Version 6.3 Service Pack 2 Release Summary
July 2006

Overview

Prospector 6.3 Service Pack 2 is an update release that contains important software corrections to rectify problems that have been reported against Version 6.3 and Version 6.3 SP1. Service Pack 2 incorporates all software corrections since the release of Version 6.3 therefore it is **not** necessary to install Service Pack 1 then install Service Pack 2.

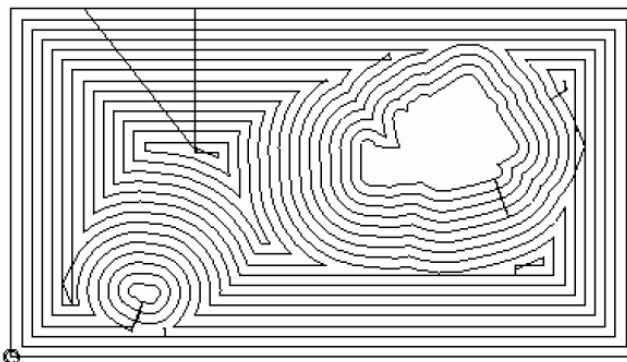
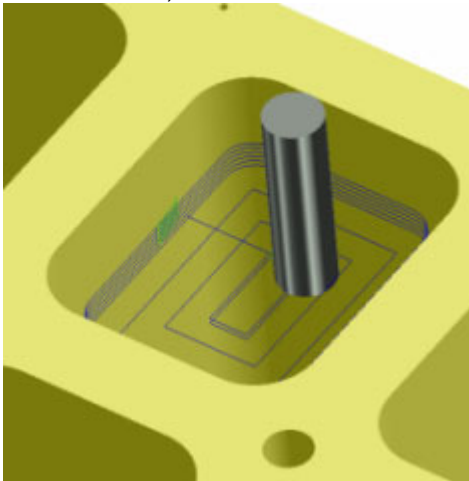
Above is an example of a single level of a clearing program created in Version 6.3. In 2 areas of the level, clearing cuts were missing. This has been corrected to insert the needed clearing cuts to completely clear each level as shown below:

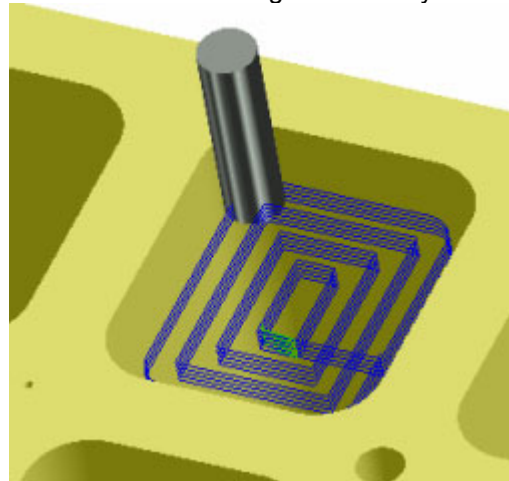
In a discrete case, several levels of a Z-Planar program omitted the clearing cuts entirely:

Part way through this program, the interior clearing cuts were omitted for several levels. Only the outer boundary was cut for these levels.

The correct results in Service Pack 2. All levels are cleared.

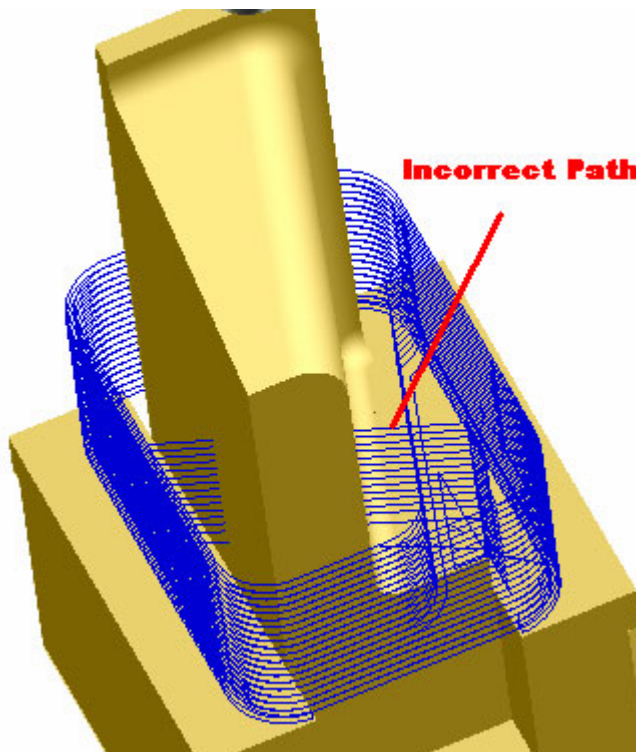
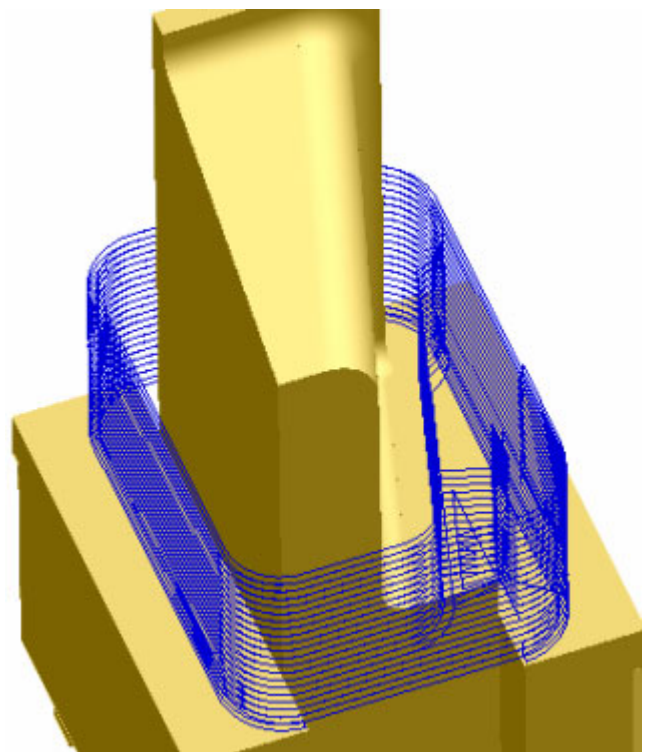
When moving to the start point of the next level, the cutter path would feed through the part data instead of choosing an interference-free path:

On just certain levels of this job, the program does not use an interference-free path to return to the start.

The correct results in Service Pack 2.

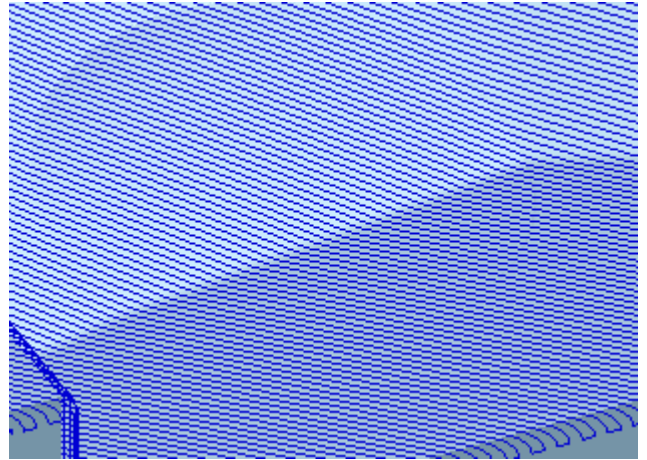
A discrete problem with certain periodic surface definitions allowed by Parasolid data could affect lace cutting:

The definition of the underlying periodic surface caused this lace cut to lift instead of staying on-surface.

The correct results in Service Pack 2.

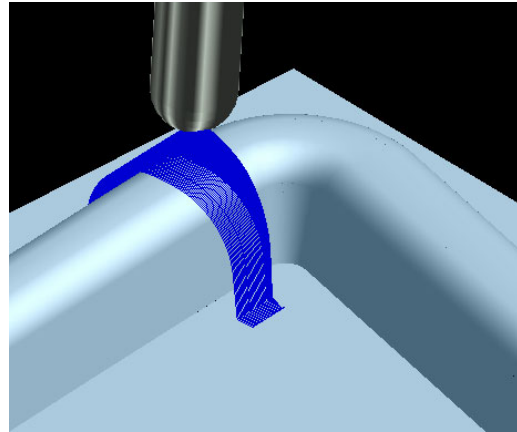
In discrete cases where there is an abrupt change in the direction of radial curves, the software could fail to produce the proper cuts. An example is a sharp corner as shown below:

In the corner of this part, the radial program doesn't follow the inside corner of the radial curve. It wrongly continues on over the part until it intersects the curve.

The correct results in Version 6.3 Service Pack 2.
